Re: *Design Exception #12-07, Cobble Creek Subdivision PP 2006-332*

SUBJECT: Cobble Creek TEDS Exception Request

DESIGN EXCEPTION REQUEST 12-07

Project: Cobble Creek Subdivision

ALTERNATIVE NO. 1

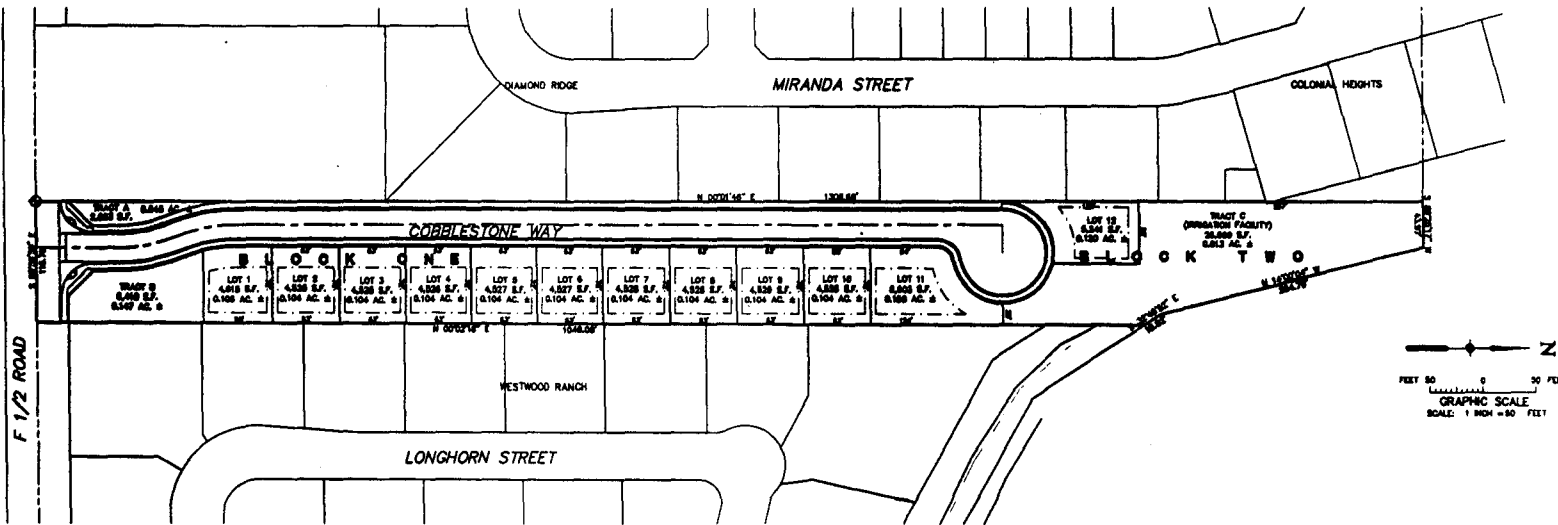
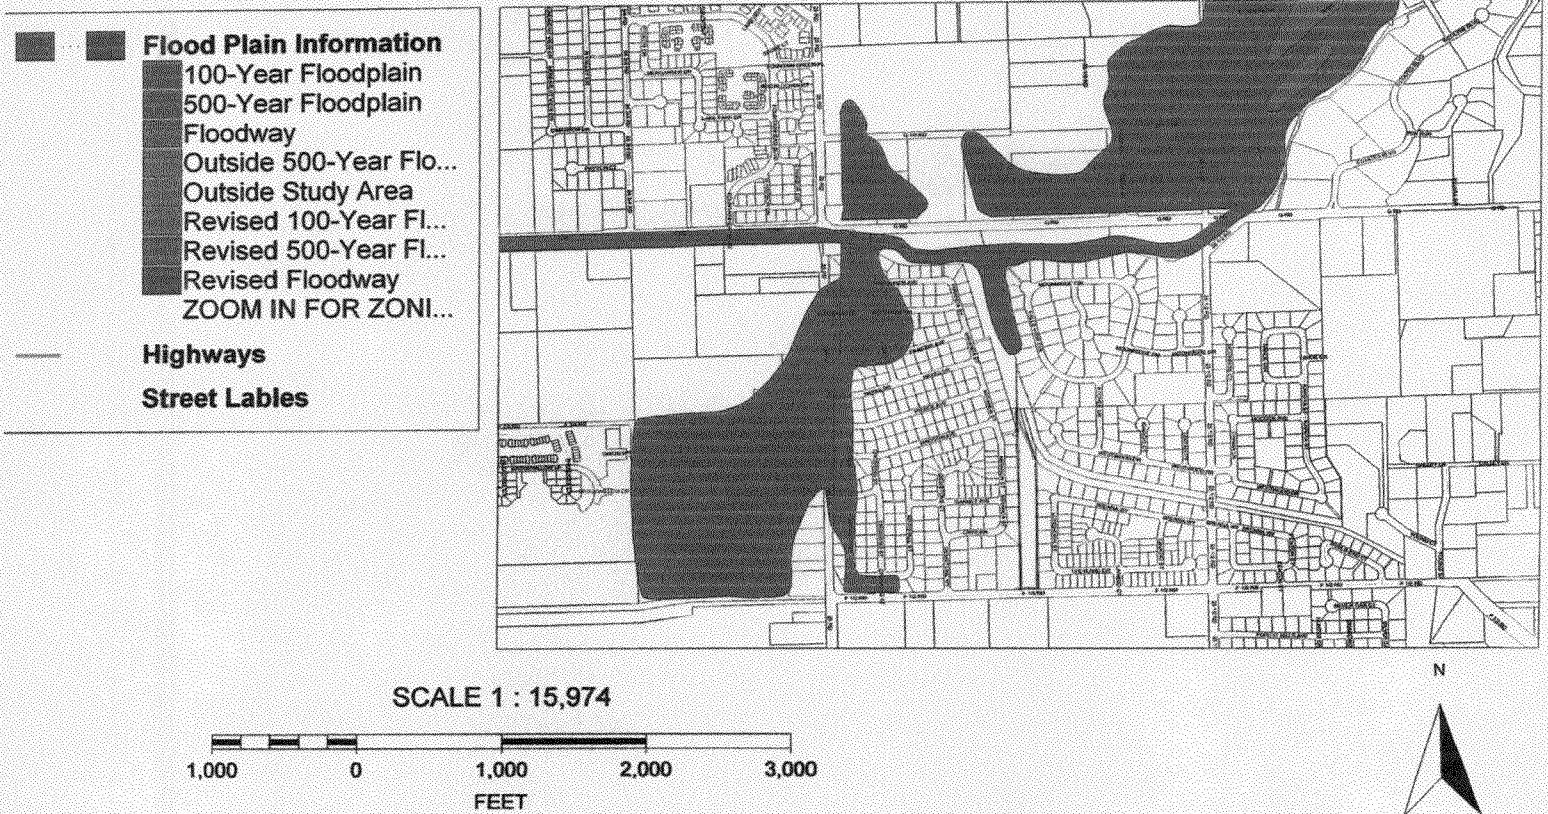
Yes. Numerous layouts have been tried. *See Attachment E.*

DEVELOPEMENT CONSTRUCTION SERVICES GRAND JUNCTION
COBBLE STONE SUBDIVISION
WEST CURB RETURN OPTION 1

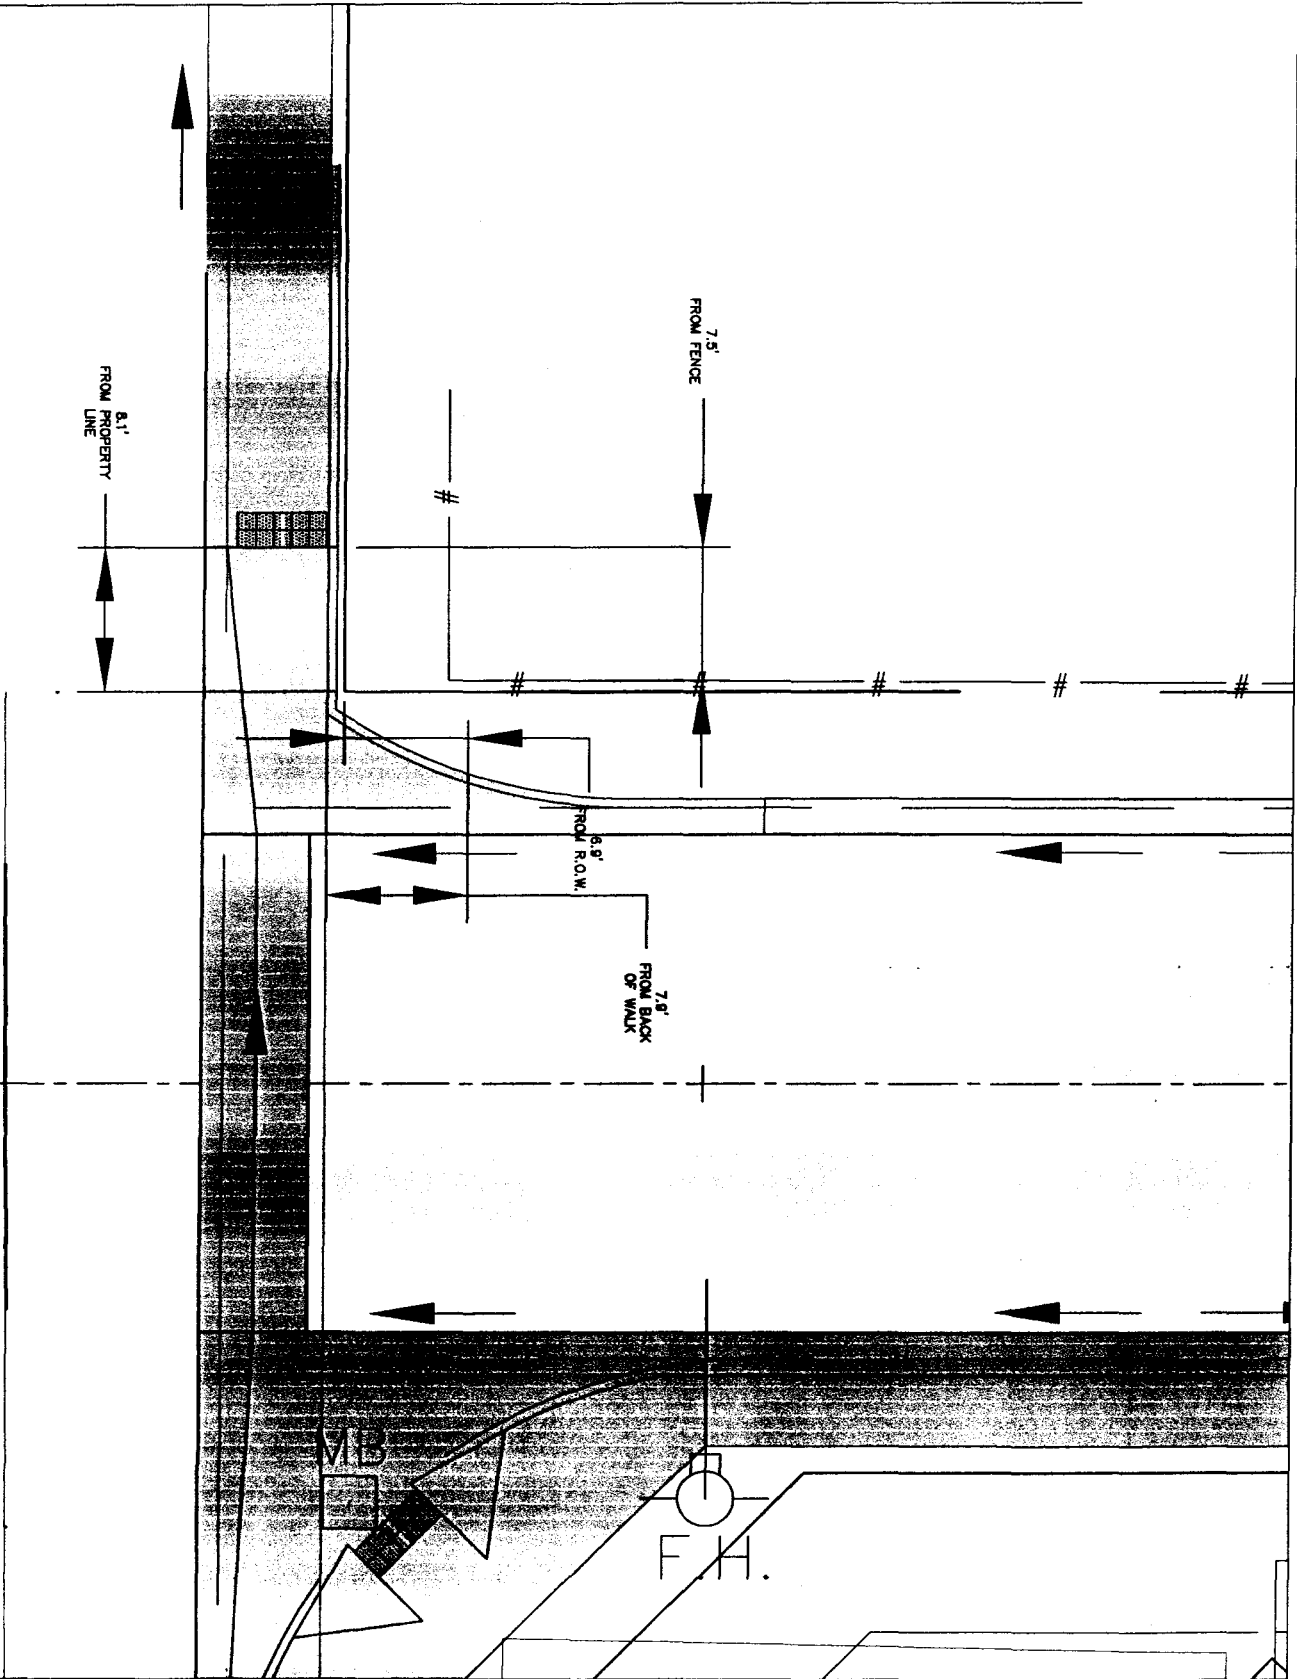
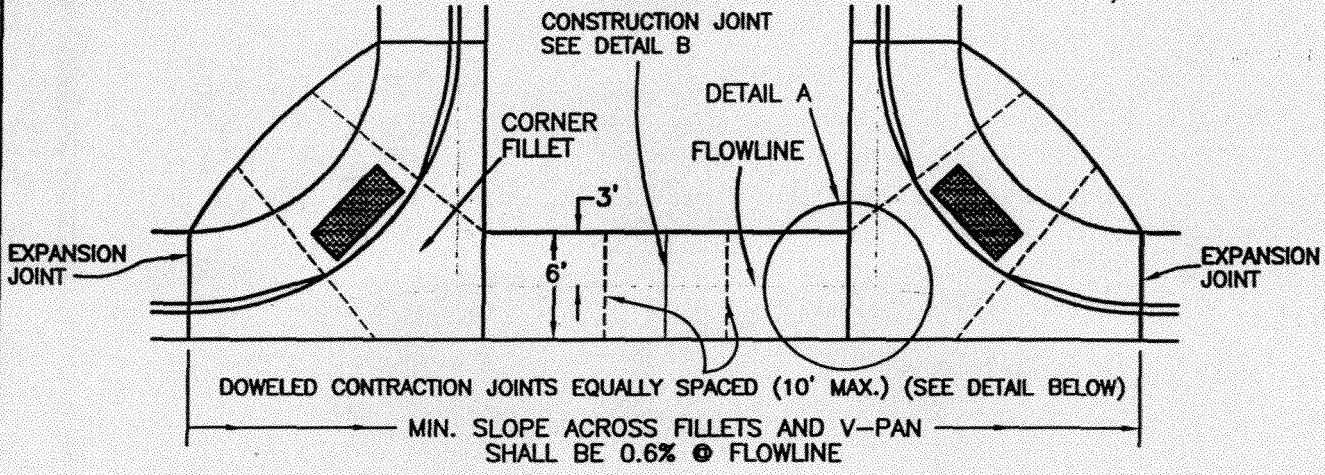
Please find attached the committee's decision for the above referenced request. Your request for a non-standard curb return and handicap ramp design on the west side of the subdivision entrance was **denied**. The remaining three items were approved as requested.

#1 Denial, they show alternative 11 in exhibit E which meets standards.

- a. **Description** – Non-standard curb return and handicap ramp design on the west side of the subdivision entrance at 2524 F ½ Road.

- Move the handicap ramp from the standard angled position used for sidewalks coming from each direction; to an in-line ramp along F ½ Road.
 - Place the handicap ramp far enough back from the intersection to eliminate conflicts with pedestrians and vehicles making right turns onto F ½ Road.
 - Provide adequate room for rear axle tracking on large trucks turning right onto F ½ Road.
 - Adjust curb return to eliminate encroachment onto neighboring property.
- An illustration of the proposed curb return is included in *Attachment C*.

Approved as Modified: REQUEST #1 DENIED
More Information Needed: _____ REQUESTS #2,3,4 APPROVED

DEPARTMENT OF PUBLIC WORKS AND UTILITIES ENGINEERING AND TECHNICAL SERVICES DIVISIONS CITY OF GRAND JUNCTION, COLORADO	STANDARD CONCRETE DETAIL	APPROVED: <i>DN</i> REVISED: <i>FEB 2007</i> DRAWN: <i>TLT</i>	PAGE C-12
--	-----------------------------	--	--------------

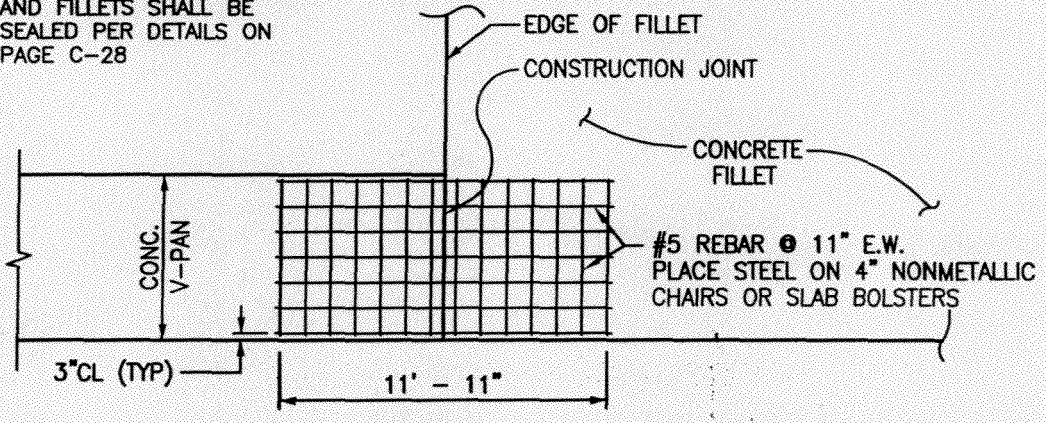
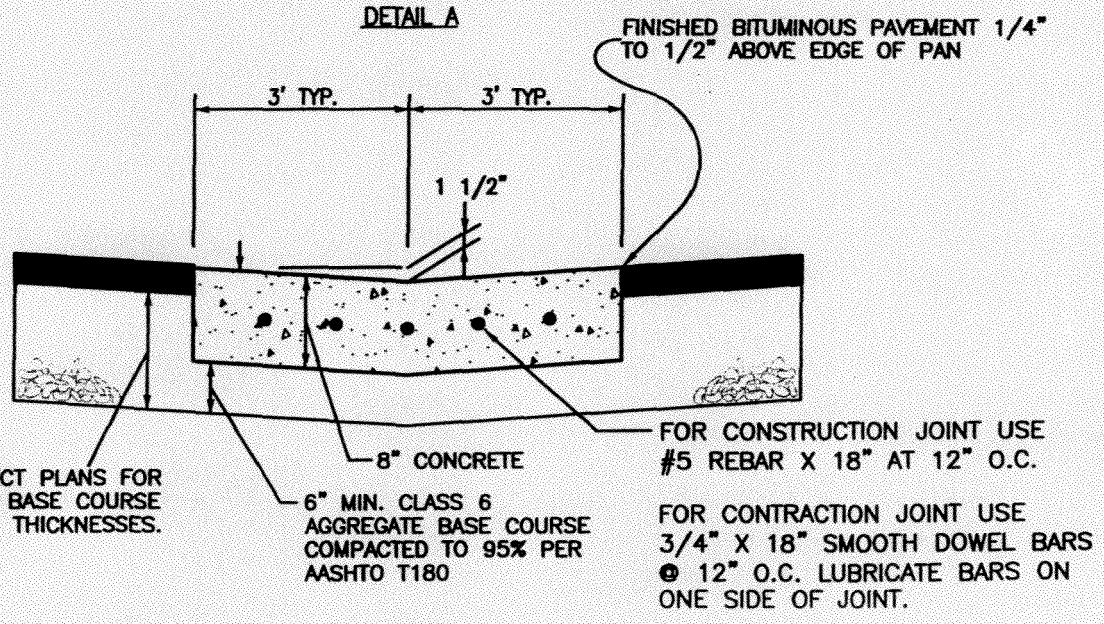
The standard curb return shown on page C-12 of the Construction Standards (Attachment D) is designed to accommodate sidewalk from both directions. Only the east side of the intersection has sidewalk coming from the north, the west side of the intersection does not have sidewalk from the north and doesn't need a northern connection.

DRIVEWAY - MONOLITHIC CURB, GUTTER AND SIDEWALK

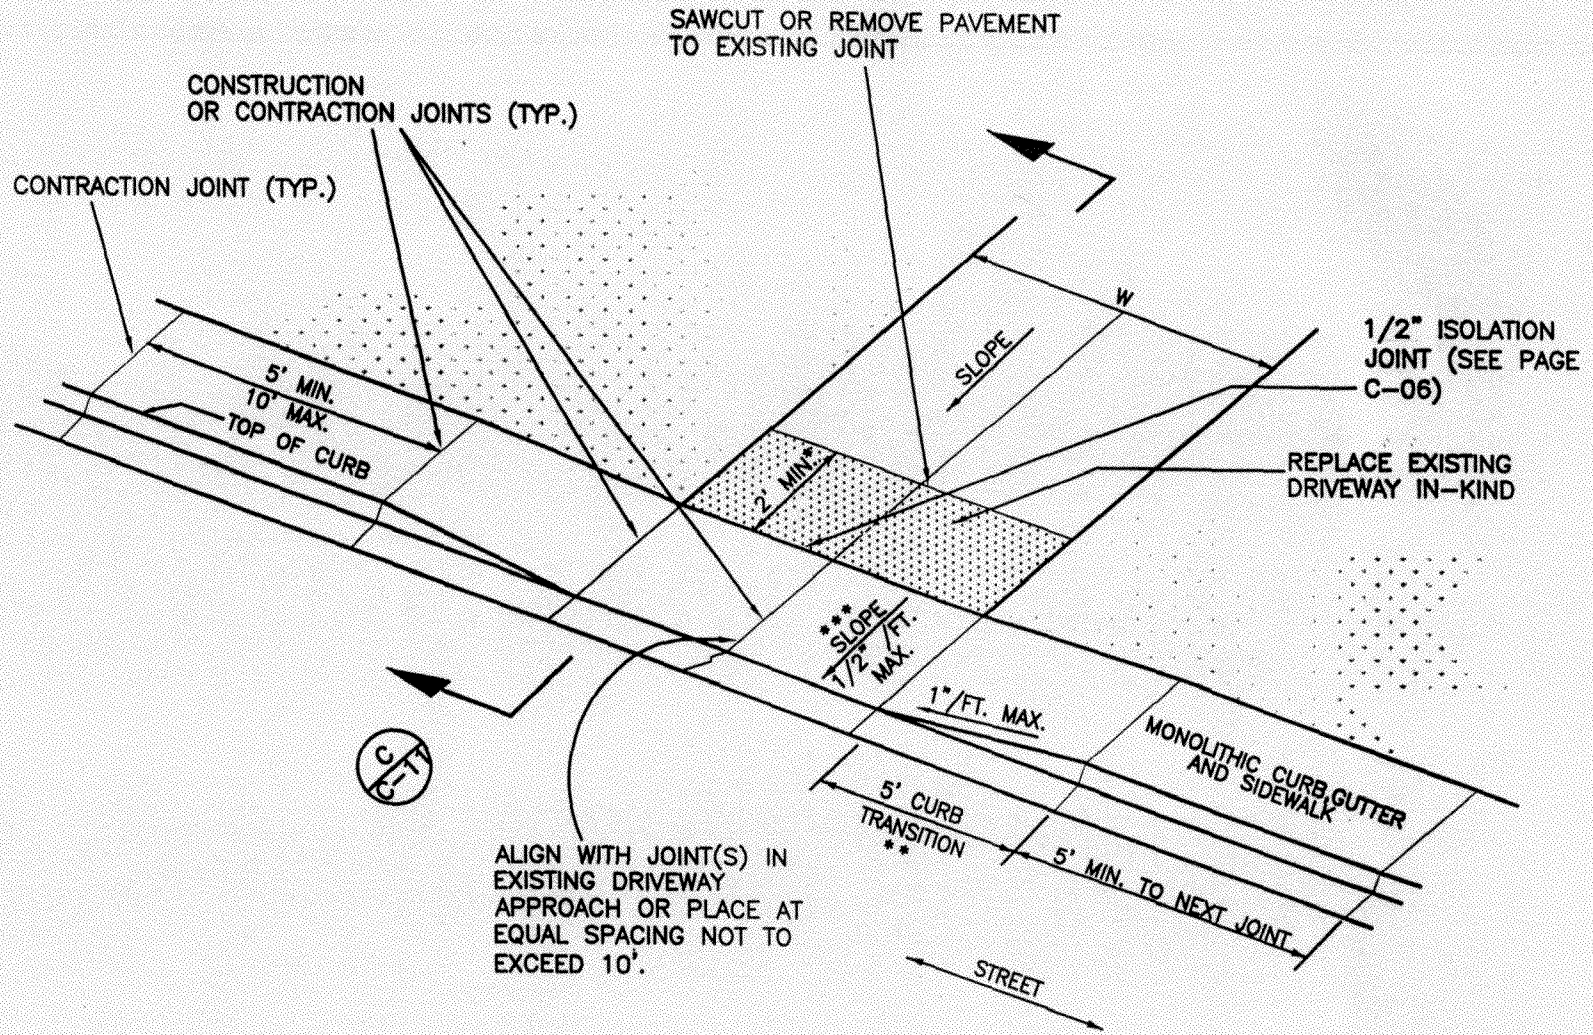
A similar design is shown on page C-08 of the City of Grand Junction Construction Standards that is used for driveways and not necessarily incoming streets. The design allows for a pedestrian ramp parallel to the street where no sidewalk connects from the side. A copy of page C-08 is included with the application. *See Attachment F.*
